**HODGESVILLE PUBLIC SERVICE DISTRICT  
UPSHUR COUNTY, WEST VIRGINIA**

**MURPHY STATION ROAD EMERGENCY WATERLINE EXTENSION PROJECT**

**ADDENDUM #1**

**SEPTEMBER 1, 2023**

SHEET No.  
**1**

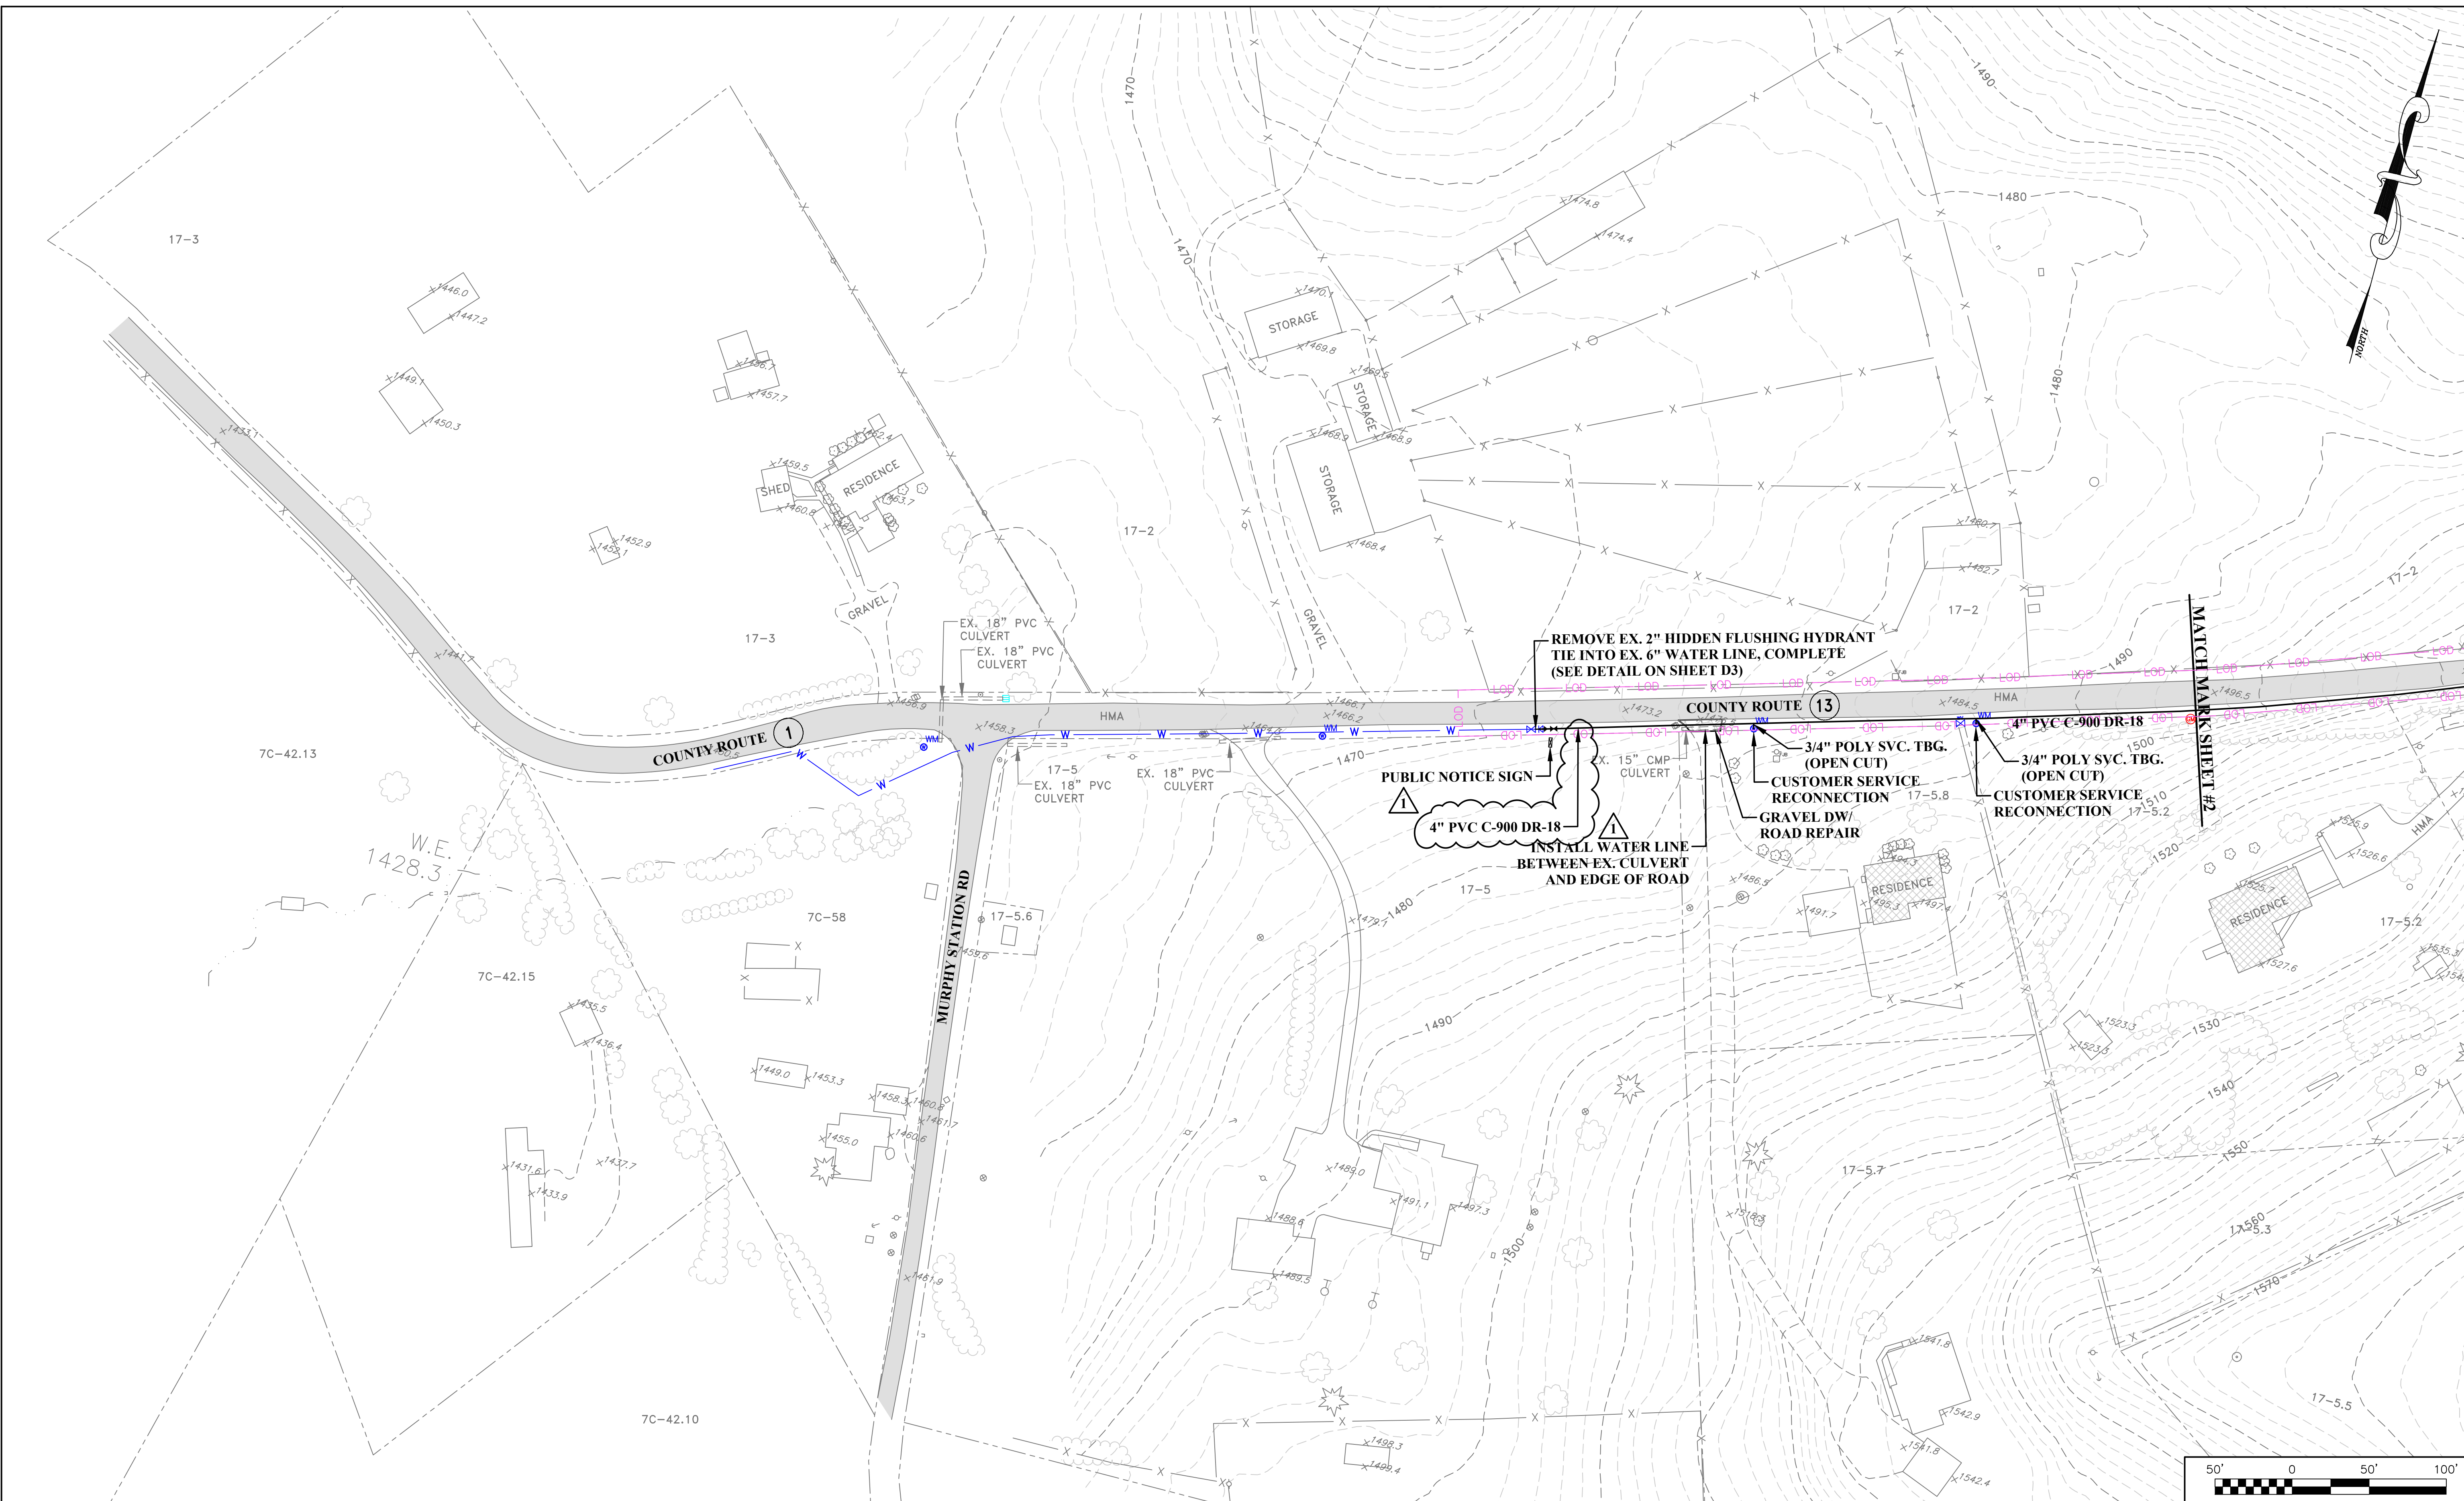
1. The callout "6" PVC C-900 DR-18" has been removed from Sheet 1. There are no changes to the Bid Form. The revised Plan Sheet #1 is included with this Addendum.
2. A waterline trench detail has been added to Sheet D1 as "Trench Detail." The revised Typical Water Detail Sheet #D1 is included with this Addendum.

Should there be a bid line item for 6" PVC C-900 DR-18?

On sheet 1, what is to be done with the existing 2" Flushing Hydrant once removed.

No. Sheet 1 of the plans has been updated to remove the call out for 6" PVC C-900 DR-18. The 6" line will be reduced to 4" at the tie-in as shown in the detail "Tie Into Existing Waterline, Complete" on sheet D3. The revised Plan Sheet #1 is included with this Addendum.

The existing flushing hydrant will be returned to the PSD once removed.
